Land Use Committee Report

City of Newton In City Council

Tuesday, January 28, 2020

Riverside Urban Design, Site Design, Open Space, and Grove Street - Peer Review

Building 1: Office

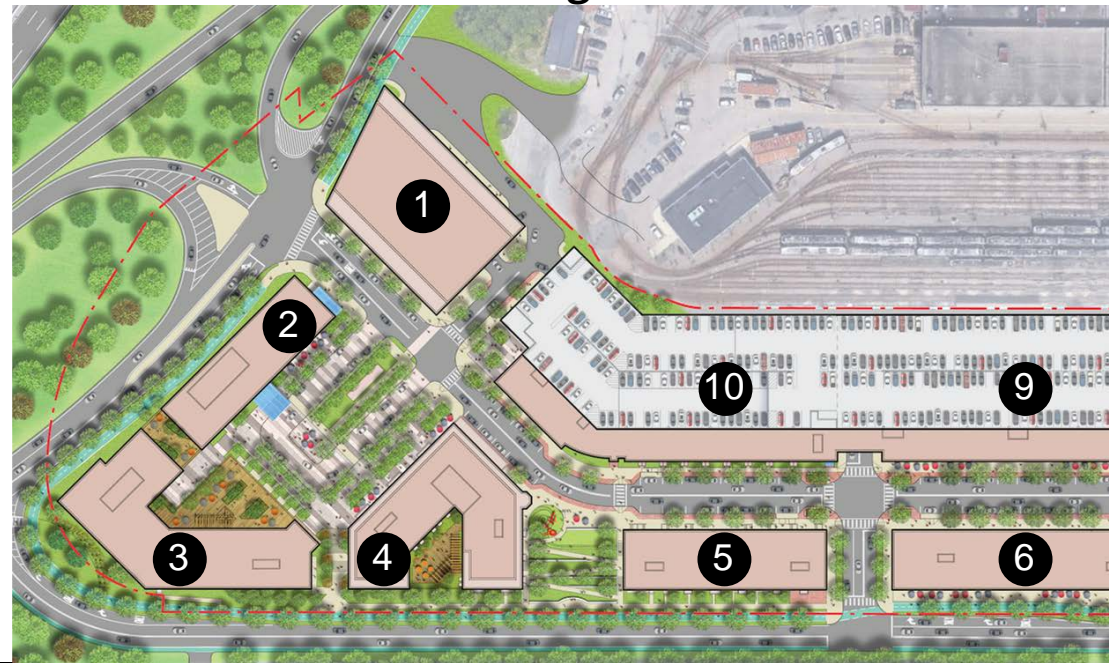
1. Reduced height is more complimentary to the scale of the project's other buildings.
2. Footprint realigned toward Main Street, which is sensible given the overall project downsizing, and will help to activate Main Street.
3. Important to find ways to add transparency and activation to the ground level.

Buildings 3 & 4: Residential

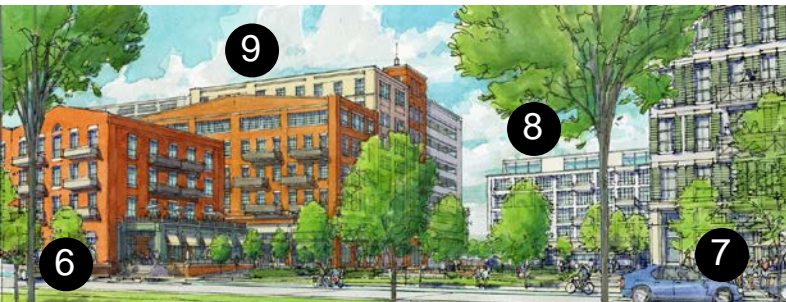
1. Removal of parking from Building 3 has decreased mass, activated frontage (potential for further improvement with exterior entrances to ground floor units), and created a more inviting public realm.
2. Plan of Building 4 has been improved with a better relationship to Grove Street.
3. Building 4's retail component and the hotel will help to activate the hotel green.
4. Reduced parallel parking could expand Green.

Buildings 9 & 10: Residential & Parking

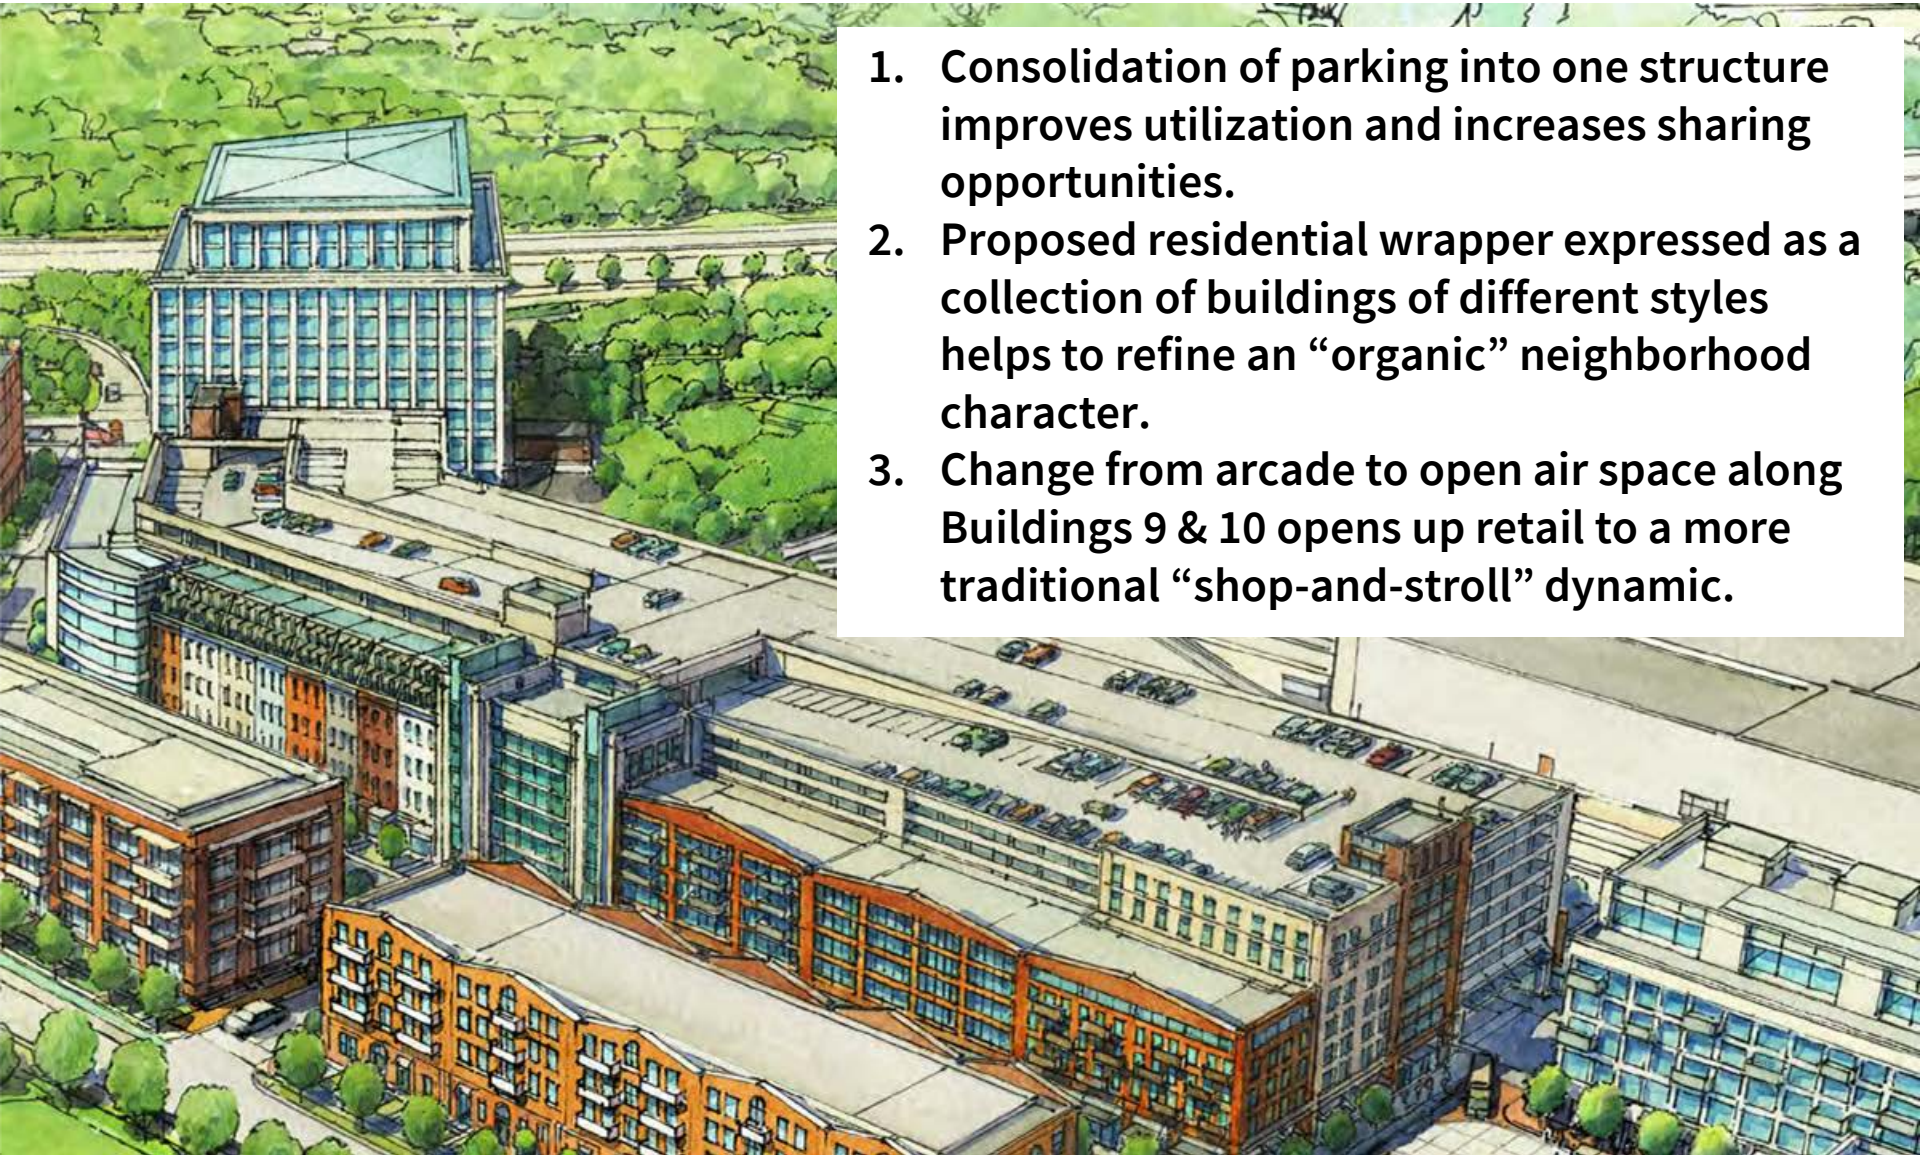
1. Consolidation of parking into one structure improves utilization and increases sharing opportunities.
2. Proposed residential wrapper expressed as a collection of buildings of different styles helps to refine an “organic” neighborhood character.
3. Change from arcade to open air space along Buildings 9 & 10 opens up retail to a more traditional “shop-and-stroll” dynamic.

Shadows

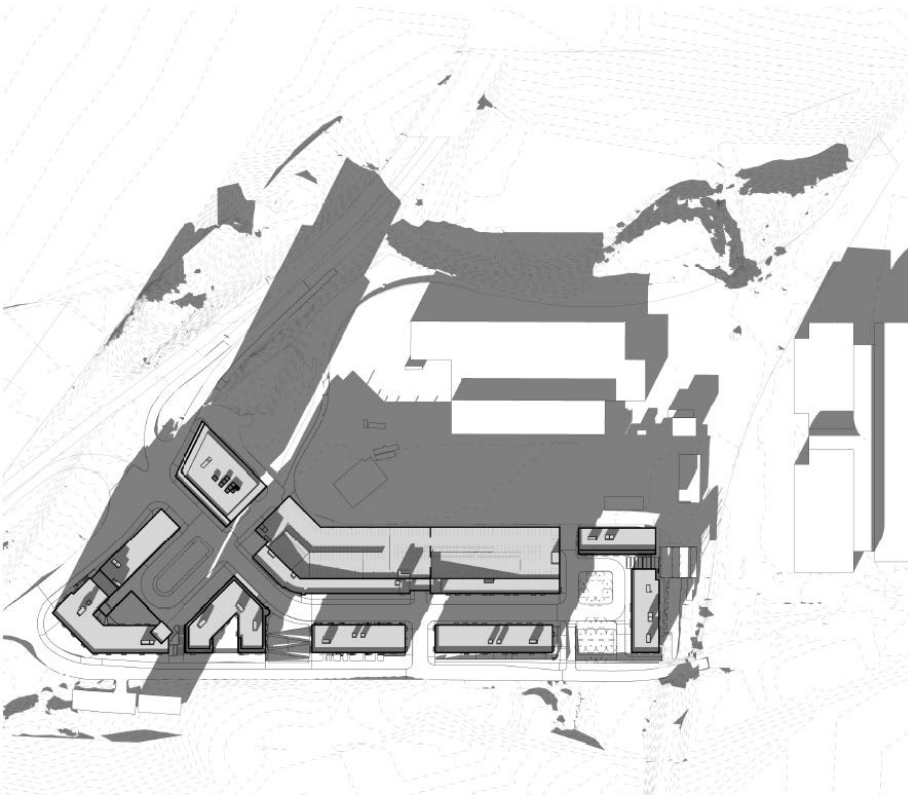
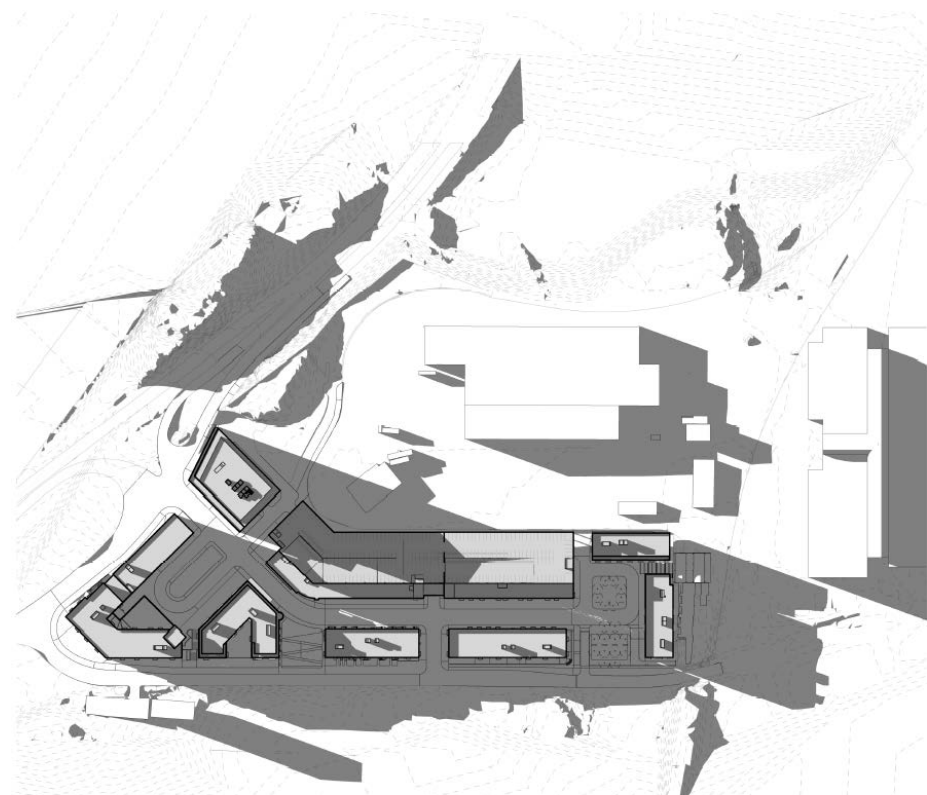
1. The shadow study indicates that shadows are contained within the site except for during some winter afternoons when shadows extend onto the southern side of Grove Street.

Open Space

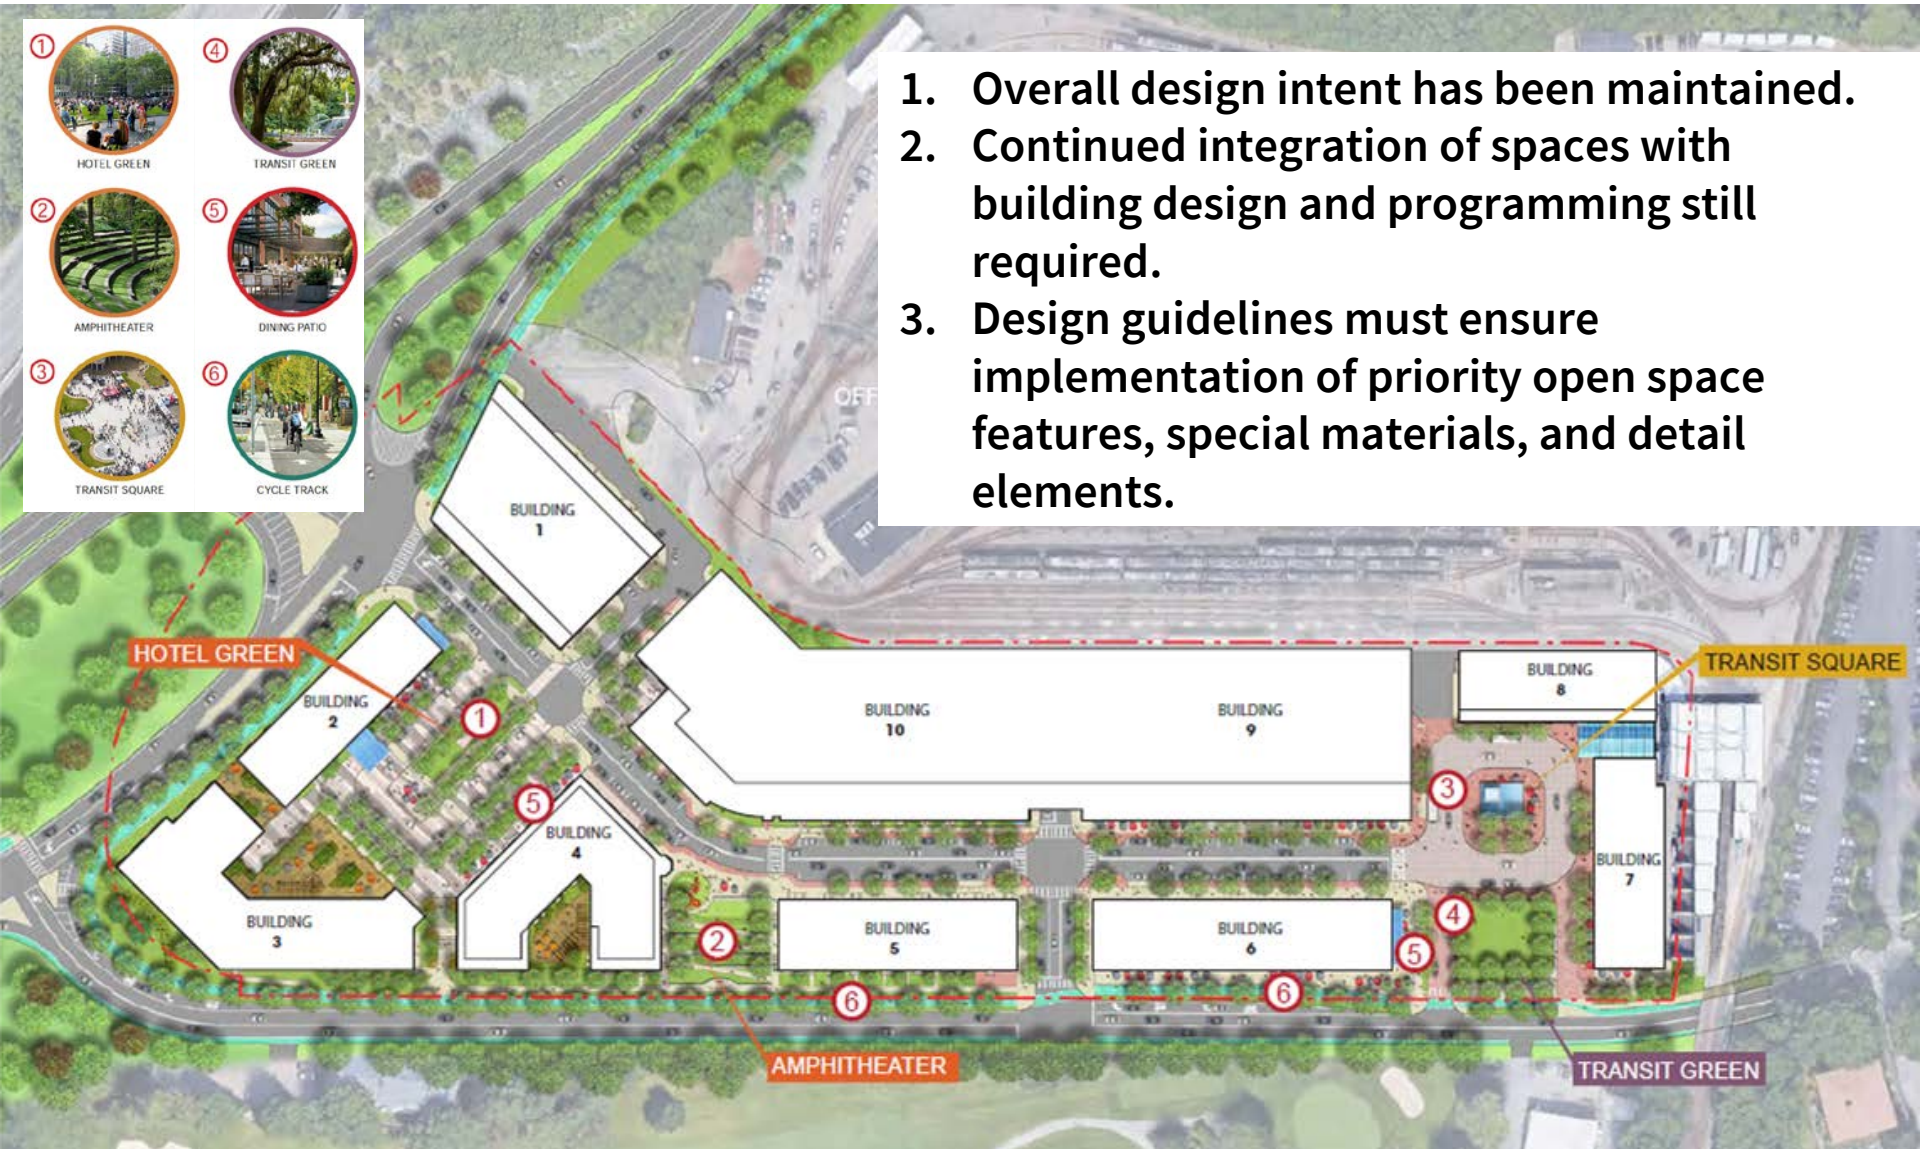
1. Overall design intent has been maintained.
2. Continued integration of spaces with building design and programming still required.
3. Design guidelines must ensure implementation of priority open space features, special materials, and detail elements.

Hotel Green

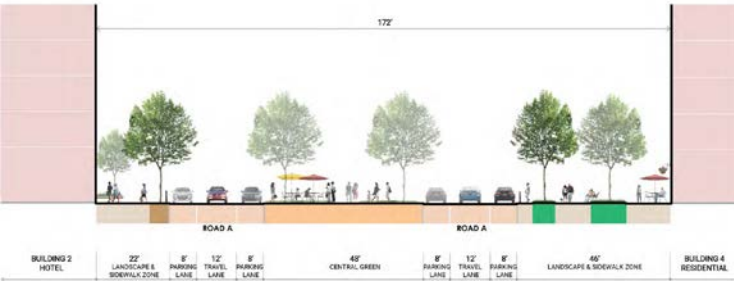
1. The design has not changed significantly.
2. Building modifications will help pedestrian environment.
3. Asymmetrical relationship with Buildings 1 and 10 will require care with detailed design.
4. Removal of parallel parking to be studied. Additional loading detail & ADA connectivity required, especially regarding the staircase connection between Grove and Main Streets.

Amphitheater Green

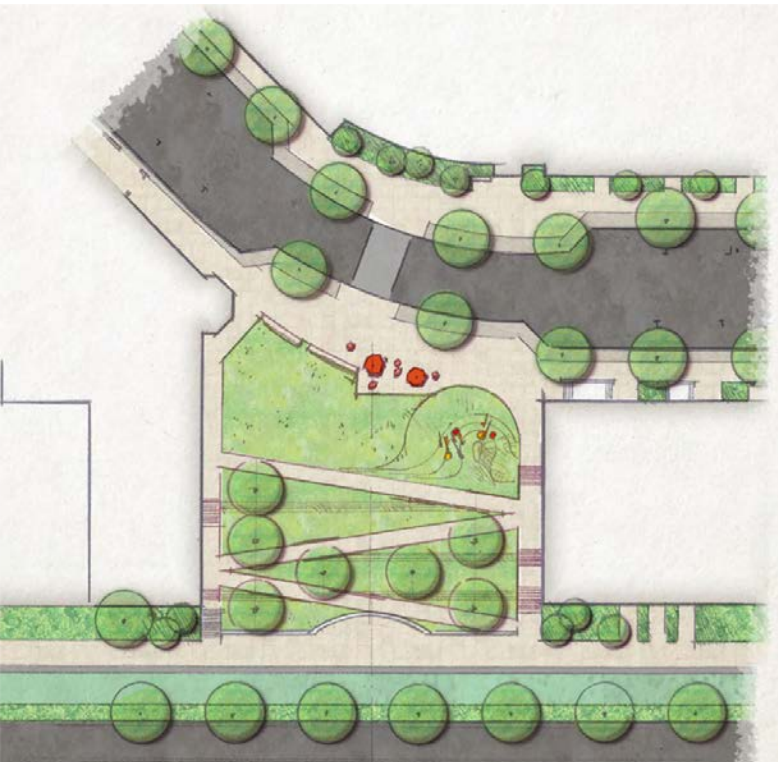
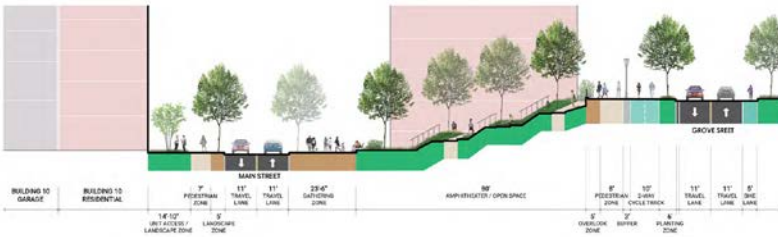
1. Space has not changed.
2. Clarification of knoll location is required.

Transit Square: many competing activities

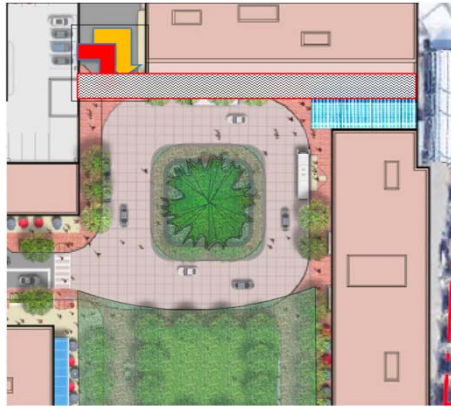
- Move bike shelter to garage, include showers, bike lockers
- Maximize green space for residents' "front yard"
- Add shelter/reduce conflicts at drop off/pick up areas
